Office Action Summary

Application No. 10/798,619	Applicant(s) LYON, ZACHARY W.	
Examiner Urszula M. Cegielnik	Art Unit 3711

DETAILED ACTION

FIG. 2

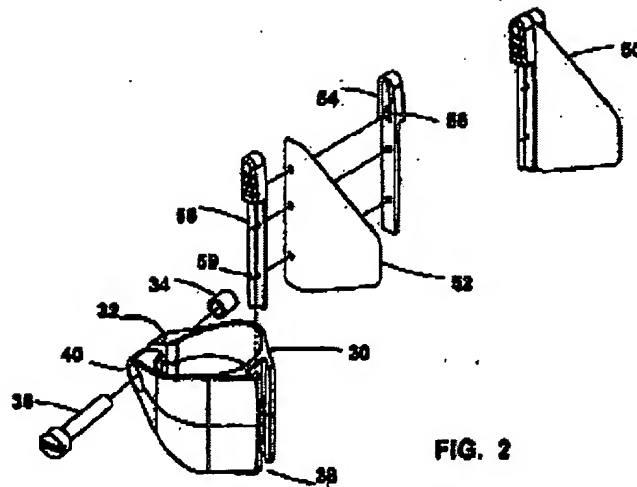
Coleman discloses a vibratory member (52) configured to be vibrated by the spokes of a rotating wheel; and a main body supporting the vibratory member (52) on the vehicle, the main body further comprising an identity plate (54,56); the identity plate (54,56) comprising one or more panels (paragraph 0041, lines 8-9) bearing identification indicia or decorative elements (paragraph 0056), the panels being selectively and releasably attached to the main body (*the panels are attached via reference parts 54,56, which is removable via sliding into portion encompassed by reference part 30 while reference part 38 {main body} stays attached to the vehicle frame, see Figure 2*) such that the identification indicia or decorative elements on the vehicle can be changed by replaced a panel attached to the main body without removing the main body from the vehicle (paragraph 0042, lines 26-29); the vibratory member (52) snaps into a socket (30) on the main body (38) (via grooves of flapper mount assembly 50 and raises within the channel of the mounting clamp enclosure 38); the socket (30) having an inner (the inner portion of reference part 30) and outer rings (the outer portion of reference part 30) of the socket; the vibratory member is configured to snap into

With respect to the zip tie fastening element, Coleman recites that a variety of other fastening means may be used such as ties, snaps, buckles as well as screws to secure the flapper mount assembly in the enclosure 38 (paragraph 0042, lines 29-32). Coleman further shows apertures in the flapper mount assembly to be used with the above recited fasteners (Figures 2 and 5A).
